Modification of Minister's Approval

Section 75W of the *Environmental Planning & Assessment Act 1979*

Residential subdivision, Kings Forest, Tweed LGA.

Mod 2 06_0318: The modification includes the following:

Potential route of new southern east-west corridor, as required by modified term B4 of the concept plan approval

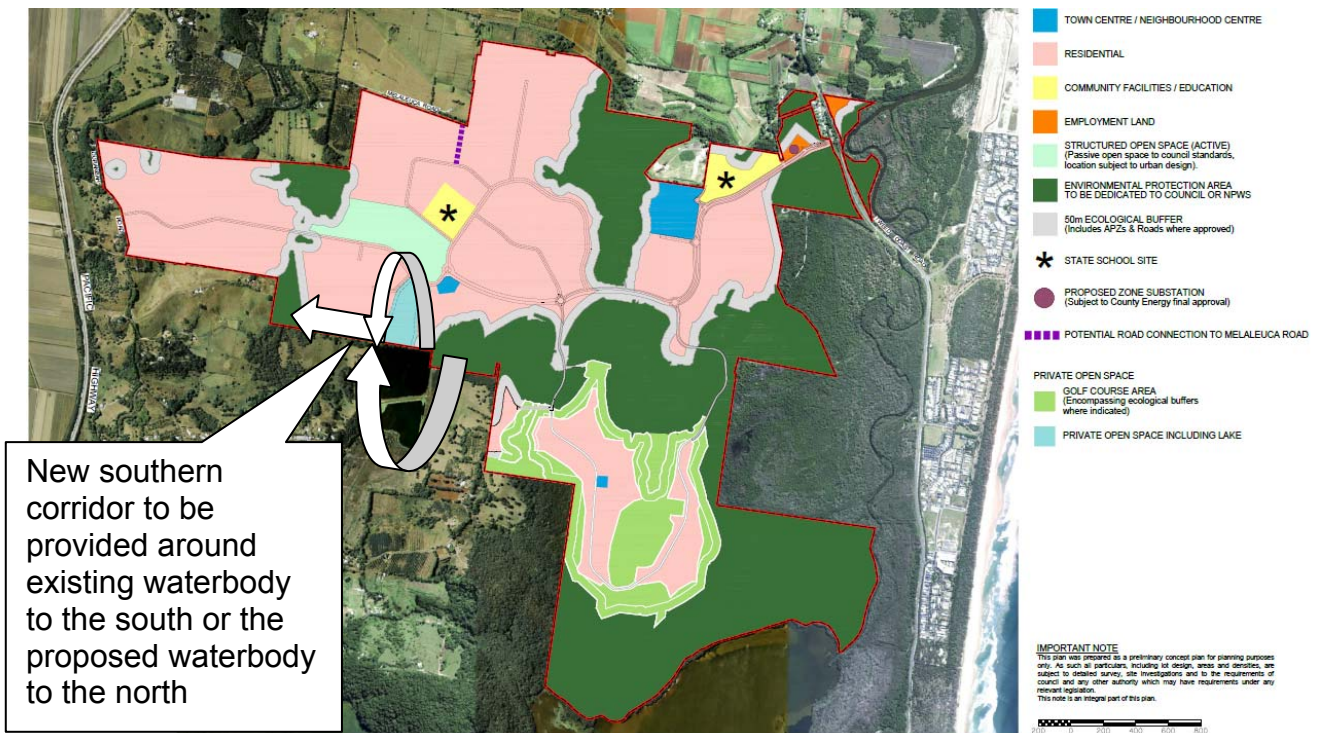
- 1) A fully revegetated east-west wildlife corridor generally 100 metres wide (with a minimum of 50 metres at any one point) shall be constructed between the existing central east-west wildlife corridor and the existing native vegetation separating Precinct 9 and 10 from Precinct 11, as identified in the plan, entitled “East-West Wildlife Corridor”, at Attachment A to this approval. The corridor shall be designed to maximise fauna use (especially koalas), continuity with existing vegetation and should consider restoration works on surrounding properties. The details of this modification, including regeneration / revegetation of the corridor and the preferred long term protection mechanism are to be submitted to the satisfaction of the Director-General within 12 months of the date of the modified approval (06_0316 Mod 2).
